**GOVERNMENT OF THE DISTRICT OF COLUMBIA  
DEPARTMENT OF TRANSPORTATION**

**MEMORANDUM**

**SUBJECT:** ZC Case No. 16-02 – DC United Soccer Stadium

Figure 1 Overall Site Plan

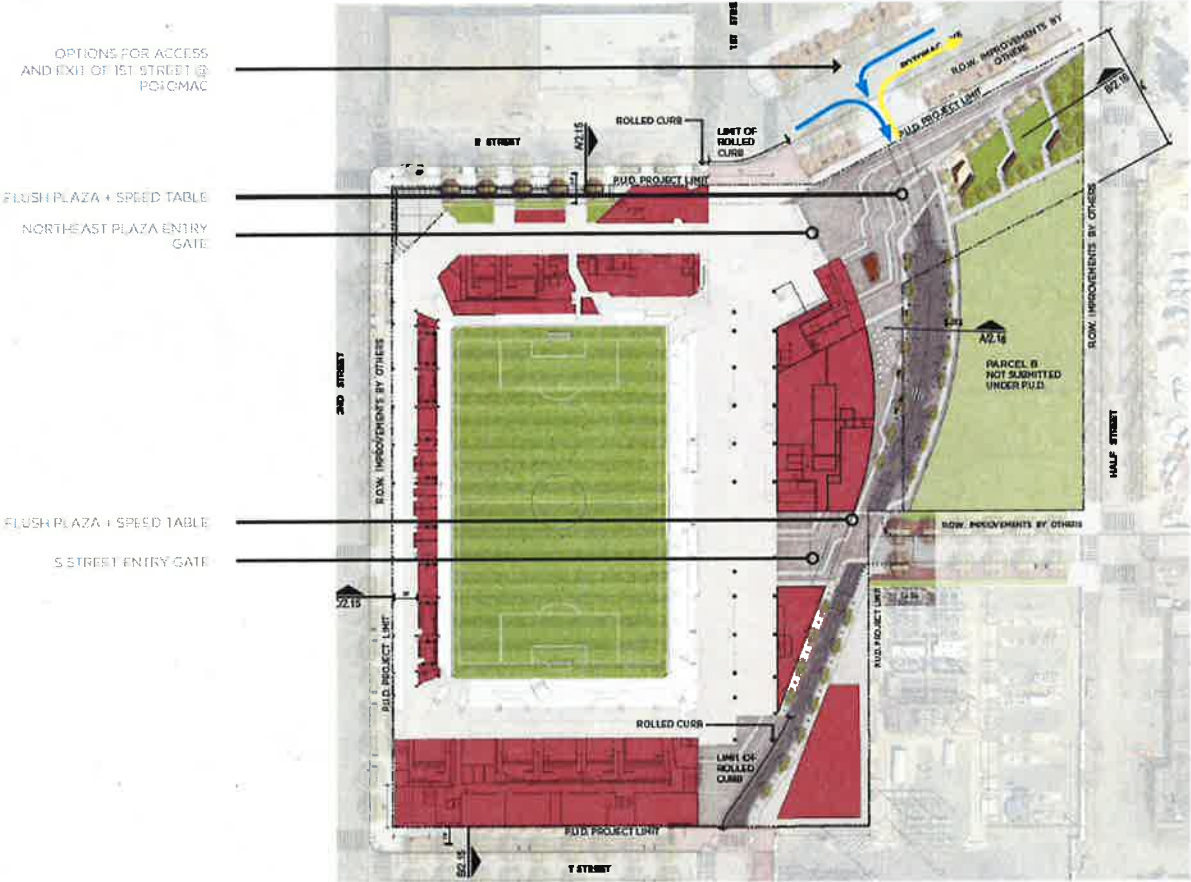
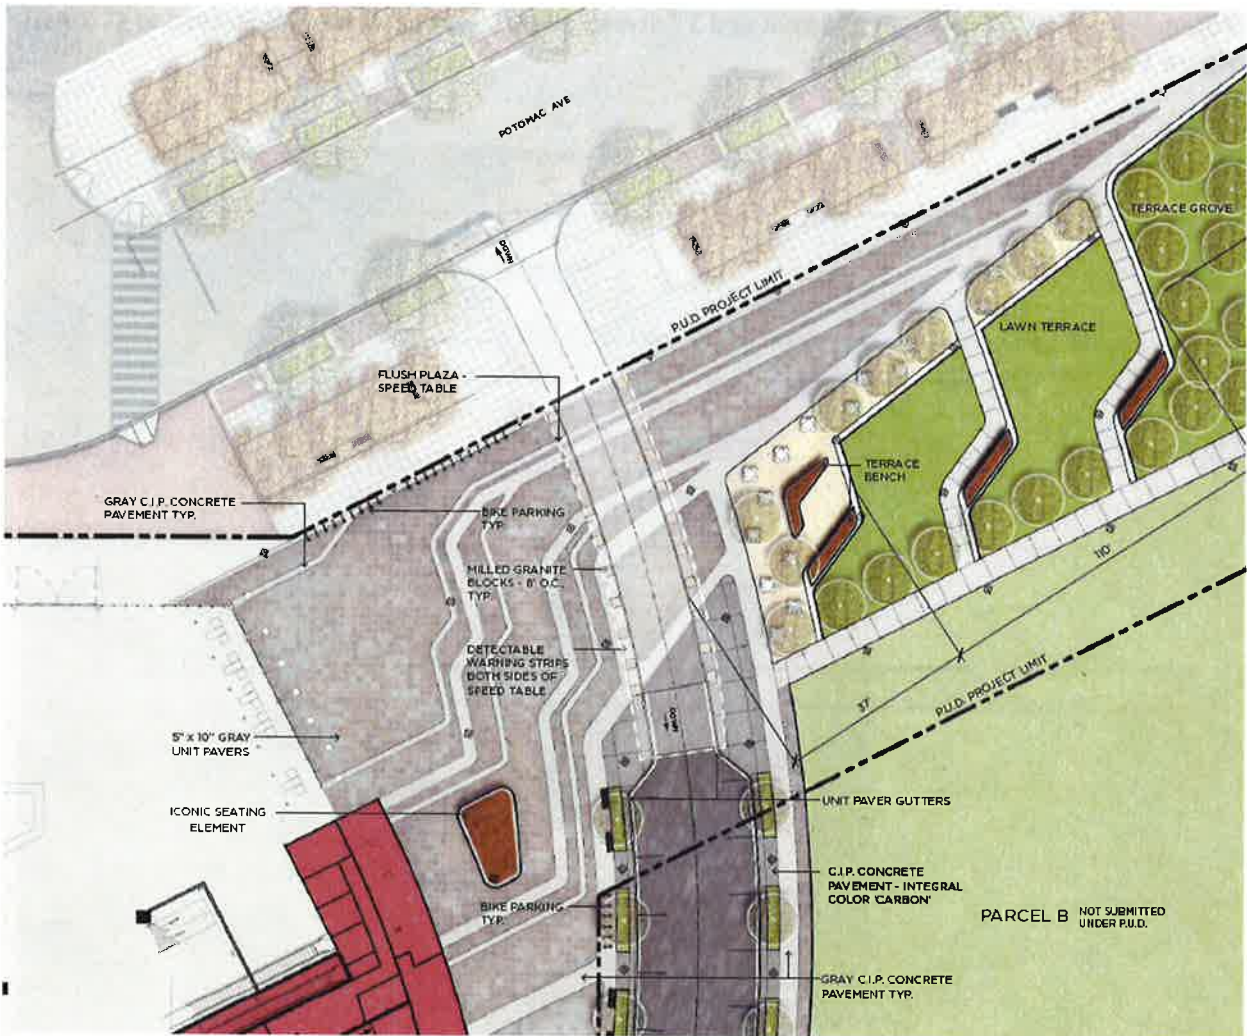
Three pedestrian gates are proposed – one each in the northwest, northeast, and east sides of the stadium. As described in the Travel Assumptions section, the majority of patrons are expected to arrive from northeast of the site, thus the northeast gate is likely to be the main access and egress point for patrons. As shown in Figure 2, a private plaza adjacent to and on axis with Potomac Avenue is proposed and provides queue space for patrons entering through the northeast gate. Smaller queue spaces on private space are provided at the other entrance gates.

The Applicant proposes a new private 1<sup>st</sup> Street alignment to the east of the site and the former 1<sup>st</sup> Street ROW to connect T Street with Potomac Avenue. An intersection with S Street is also created. As a private street, the Applicant is responsible for maintenance, snow removal, and curbside management and enforcement.

The street’s design varies between the northern segment (between S Street and Potomac Avenue) and the southern segment (between T Street and S Street). The segment north of S Street features one lane of vehicular travel in each direction, parking on both sides of the street, tree boxes, and sidewalks on both sides of the street (Figure 3). The segment south of S Street features one lane of vehicular travel in each direction and sidewalks on both sides of the street.

Figure 4 Approved Streetscape Improvements by the District (Source: AECOM)

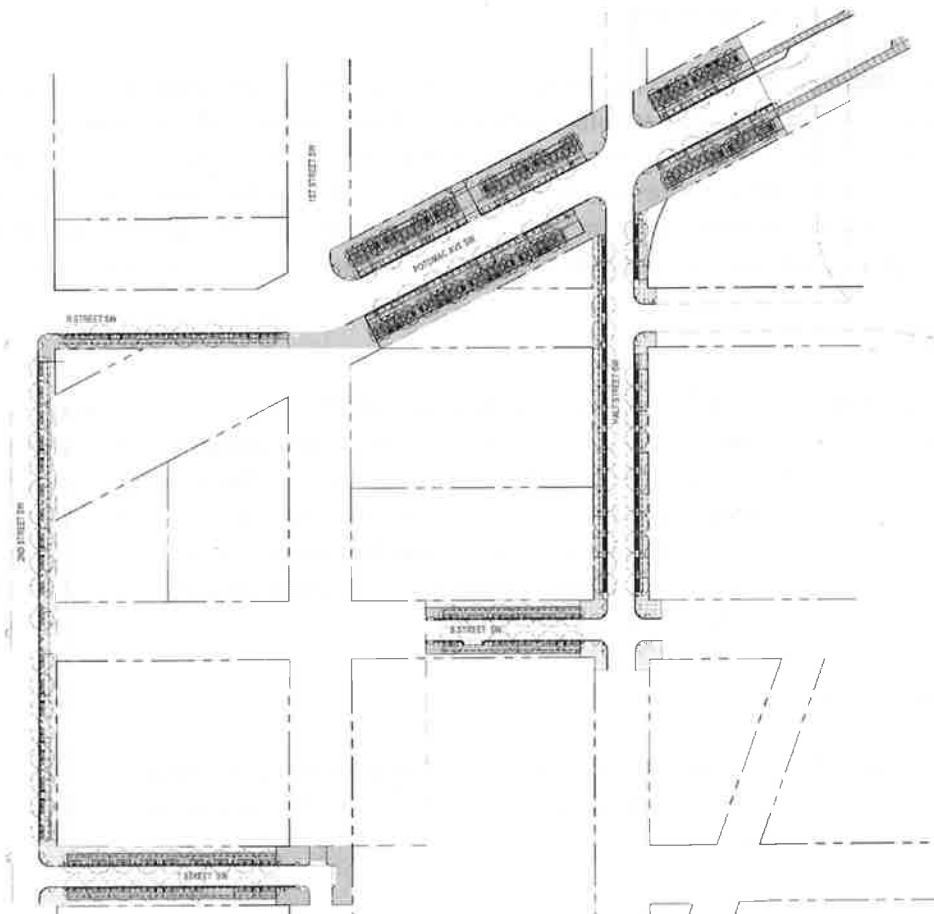
DGS and DDOT coordinated closely to develop streetscape plans for the street segments to be improved (Figure 5). The public space plans are consistent with the District of Columbia Municipal Regulations, DDOT’s *Design and Engineering Manual*, and the Buzzard Point Streetscape Guidelines. Key features of the public space plans include wide sidewalks to accommodate significant pedestrian activity, street trees and ample landscaping, areas for future sidewalk cafes, street furniture (trash cans, benches, etc.), upgraded street lights, and stormwater management strategies. Permits were issued for the public space work in June 2016.

In addition to permits needed to account for the realigned 1<sup>st</sup> Street, additional public space permits will be required of the Applicant for any additional work in public space. The PUD plans show “parklets” in the public space along 2<sup>nd</sup> Street and T Street between the sidewalk and the property line. These “parklets” feature pedestrian scale amenities such as seating, landscaping, and bicycle parking. At the time of this report, public space permits have not been approved for this work. As the plan has not received public space approval, DDOT considers the improvements to be a conceptual plan that may need to be adjusted as they progress through the public space permitting process. The elements shown in the conceptual plan are generally consistent with approved uses in public space and are likely to create the pedestrian-scale activity in the public space that is encouraged by public space regulations. Accordingly, DDOT has no objection to the “parklets” as illustrated in the conceptual plan and looks forward to coordinating with the Applicant through the public space permitting process on the final design for these features. As a result of this further coordination the conceptual plans may be adjusted in order to accommodate changes identified during the public space permitting process.

Public space permits will be required to implement the final curbside management plan. Utility vault locations have not been identified. DDOT expects utility vaults to be accommodated on private property.

The Applicant has also expressed a potential need for security bollards at the site’s perimeter that are not currently shown as part of the stadium plans. DDOT does not support bollards in public space. All security apparatuses should be located on private property.

The Applicant must work closely with DDOT and the Office of Planning to ensure that the design of any remaining public realm designs current standards and will substantially upgrade the appearance and functionality of the streetscape for public users needing to access the property or circulate around it. DDOT staff will be available to provide additional guidance during the public space permitting process. DDOT suggests that the Applicant participate in a Preliminary Design Review Meeting (PDRM) to address design related issues prior to the submission of public space permit applications.

Figure 10 Off-Site Parking Locations (Source: CTR)

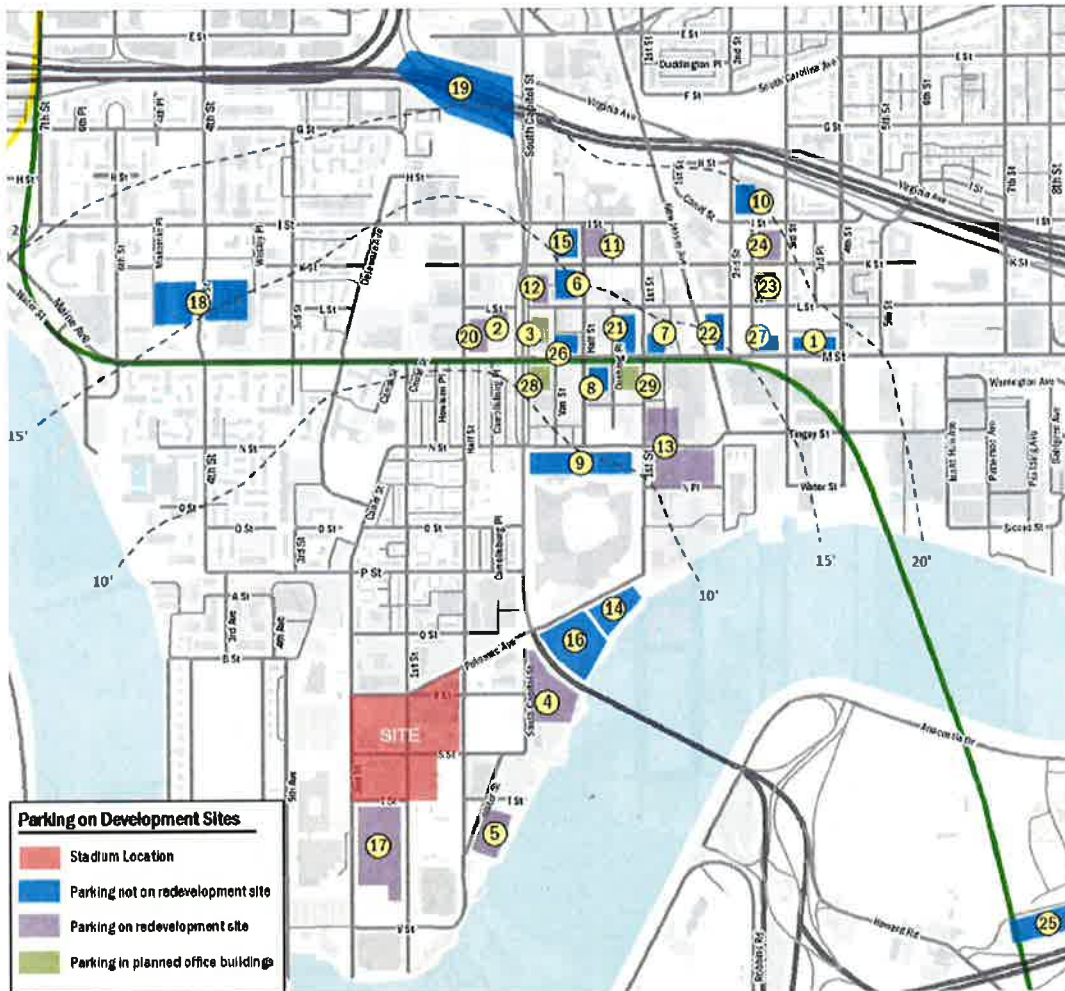
The lack of on-site parking facilities means that patrons, DC United staff, and other stadium users will need to locate vehicle parking elsewhere. As shown in Figure 11, the CTR identified over 7,000 parking spaces within a 20 minute walk of the site. Of note, over half of the parking locations are farther than the nearby Metro stations, thus providing a comparative advantage for transit usage. In addition, a majority of the parking locations identified are also used to accommodate events at Nationals Stadium.

Over time, DDOT expects the availability of vehicle parking locations to vary as off-site parking locations are redeveloped with a mix of uses and underground or structured parking facilities. Thus, the Applicant will need to continually negotiate with parking operators. The TOPP should be updated as needed to reflect changing travel patterns driven by parking location changes.

Although sufficient off-site parking locations have been identified, the stadium is likely to generate demand for curbside uses. As these spaces are likely closer and cheaper than many of the off-site private parking facilities, careful consideration of curbside parking is needed. Analysis of existing curbside uses, shown in Figure 12, indicates a significant amount of residential, metered, and unrestricted parking in the vicinity.

Figure 11 Curbside Parking Inventory (Source: CTR)

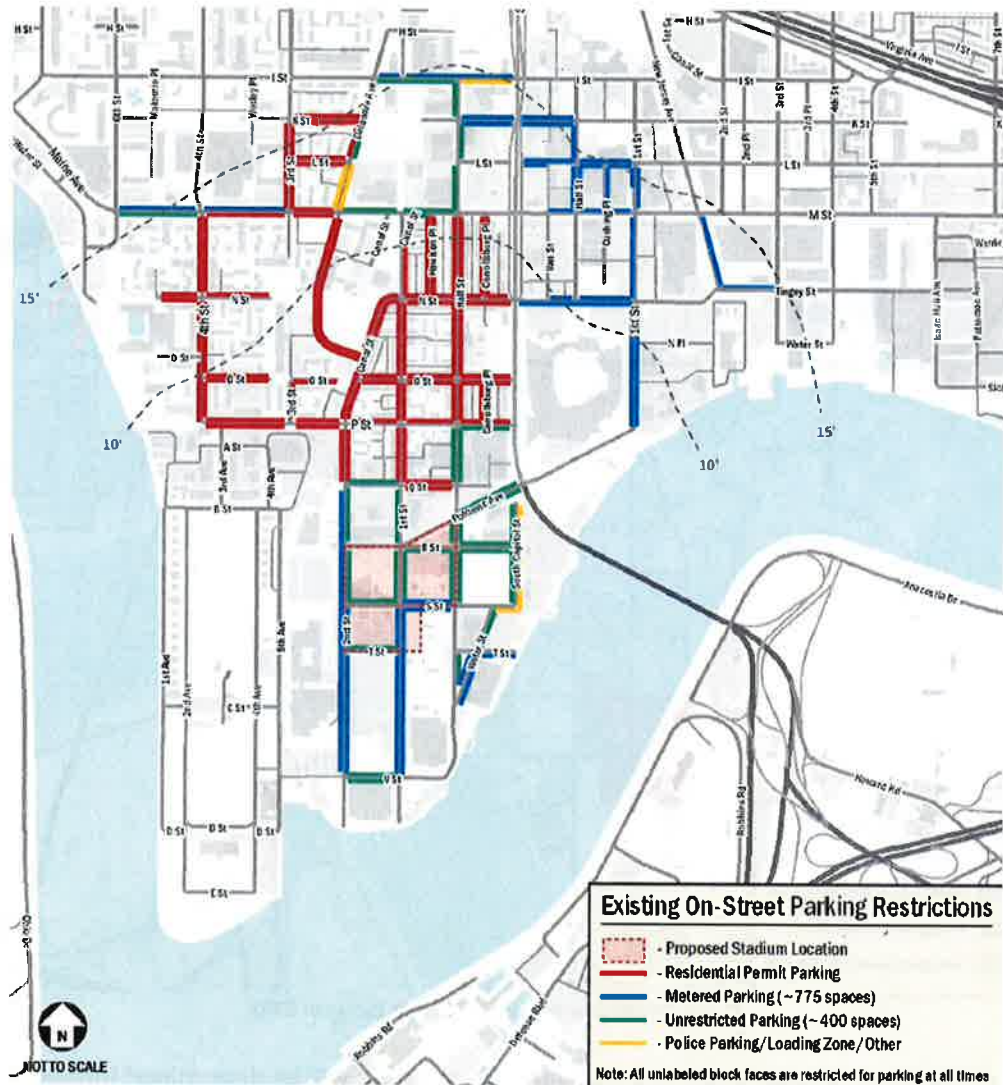
Curbside management and parking plans for event day activities will be determined through the TOPP. Several considerations that should be taken into account during the TOPP development:

- Preservation of residential parking areas for resident parking. Coordination with residents so that residential parking preservation strategies and locations reflect neighborhood desires and concerns;
- Ensuring adequate pricing and regulatory signage for all current metered curbside parking spaces, possibly including a performance parking approach similar to the area around the Nationals Stadium that increases curbside metered parking rates for stadium events; and
- Providing signage and payment mechanisms, where applicable, for all unrestricted blocks. The CTR identifies potential challenges for regulating some curbside areas due to missing curbs.

DDOT notes that as part of the TOPP development and subsequent public space permitting, the Applicant may be required to improve payment mechanisms, such as multispace meters, and signage in order to improve the curbside in the vicinity to meet the stadium's needs.
